Written Comments on Proposed Air Permit Modification

Hickman's Egg Ranch, Arlington Facility Air Permit No. 040136
32425 W. Salome Highway, Arlington, Maricopa County, Arizona

The following written comments were prepared by Kathy J. Martin, PE (OK#18254) at the request of local citizens and submitted to the Maricopa County Air Quality Department in response to public notice for public comment on the proposed permit modification.

Figure 1 – Image from Vulcan website poultry manure system using rotary dryer.
<http://getavulcan.com/chicken-manure-dryer/>

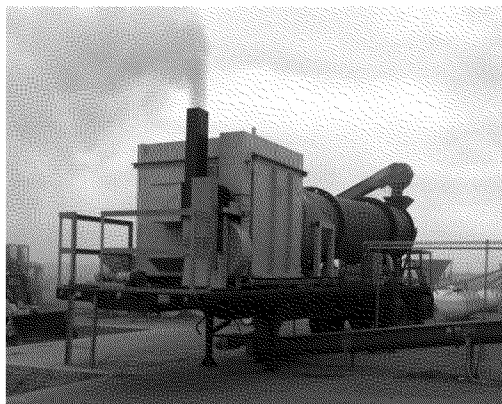
The application for permit modification date stamped received July 20, 2015 does not acknowledge the steam and dust generated during the drying of poultry manure in the rotary dryer. Online videos of similar types of rotary dryers show both steam exhaust (from the removal of moisture in the poultry manure) and dust exhaust from the on-loading of poultry manure into the equipment and off-loading of dried manure after treatment.²³
